Fwd: Proposed Massachusetts Tiling Scheme

Subject: Re: Proposed Massachusetts Tiling Scheme

Attached is our proposed tiling scheme for Massachusetts. Also attached is the QL1 AOI for reference. This tiling scheme has the 1500m tiles broken into four 750m tiles anywhere that the tile is intersected by the QL1 boundary. The tile names are based on the US National Grid Standard, with a prefix for the 750m tiles indicating what QL level is contained in that tile.

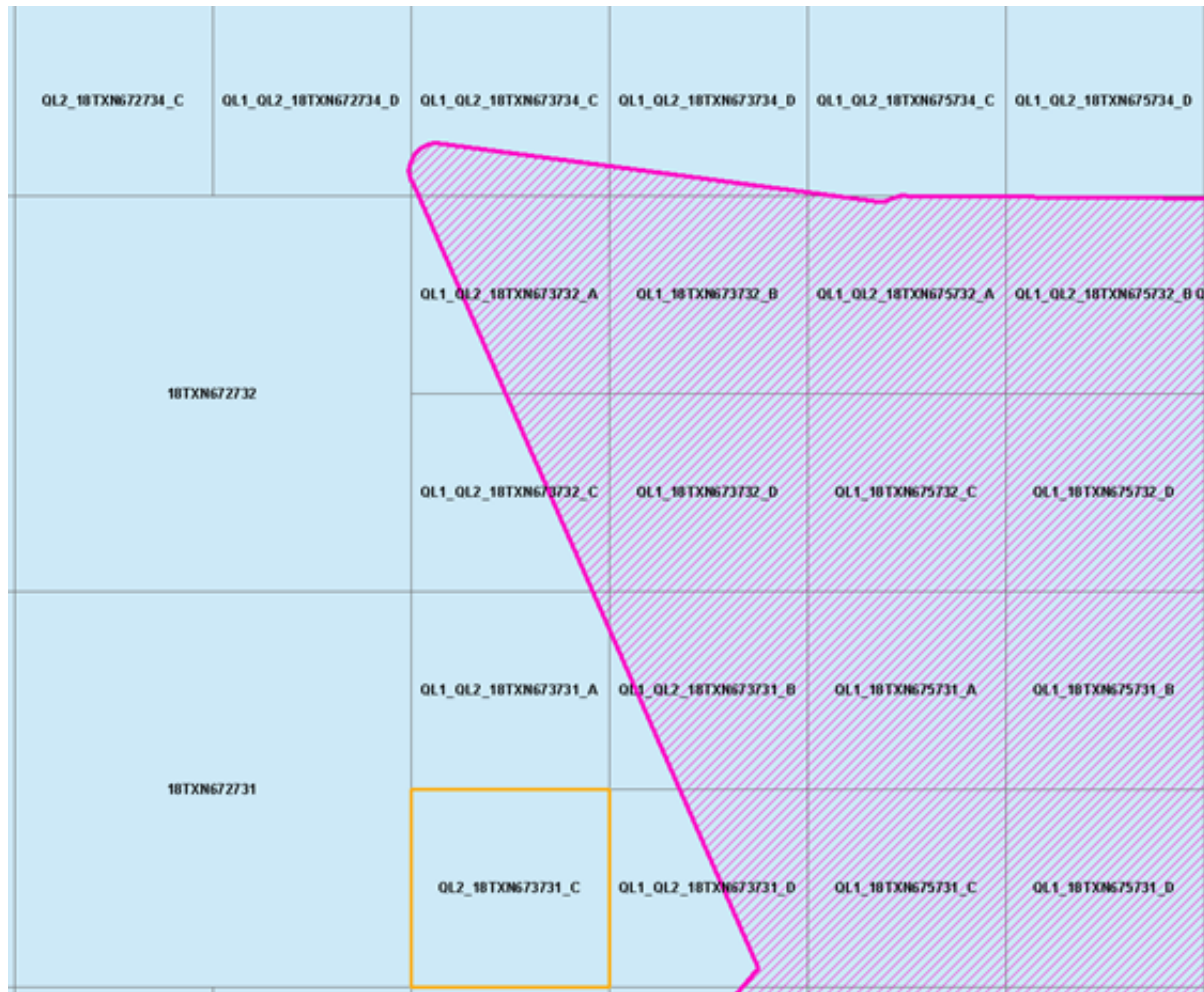
Hi Tobin – thanks for the info below. I now understand about the “prefix” designation in the tile names and what you have below is great. Also, we would like to have the "A, B, C, D" suffix designations replaced with NW, NE, SW, SE following the pattern in my graphic below.

Below is a screenshot of the proposed tiling scheme naming conventions. To indicate the positioning of the 750m tile "within" the 1500m tile we used "A, B, C, D" as a suffix but we could just as easily use "NW, NE, SW, SE". The prefix of QL1, QL2, or QL1_QL2 is used to indicate the data quality level contained by the tile. The orange tile at the bottom of the screenshot is an example of a "QL2 only" 750m tile. I can set up a conference call if this is still not clear.

Hi Pat – With one suggested addition (clarification?) and one question, the proposed index and naming scheme are what we had envisioned. The one area we were not quite sure on how the names would work is that for the QL1 tiles. As noted below the individual QL1 tiles will be one quarter of the 1500m x 1500m QL2 tiles. Perhaps this is intended or I have not fully understood the info below, but it would be VERY helpful if the QL1 tile names could indicate their position

I am confused by the reference to, "...a prefix for the 750m tiles indicating what QL level is contained in that tile." Does this mean that a QL1 quarter tile will exist even if there is no QL1 data in a quarter tile and that you would know from the tile naming scheme that even tho it was a quarter tile it only contains QL2 data?

It will not be an issue at all to use the directional suffix designations. We will make that change on our end.

As for the transition between the QL1 and QL2 data, there will not be a stair step where the two data types meet. We have methodology in place to vertically match and feather the datasets together, resulting in a smooth transition from one density to the other. Let us know if you have any other questions or need further clarification and we'll be happy to help.
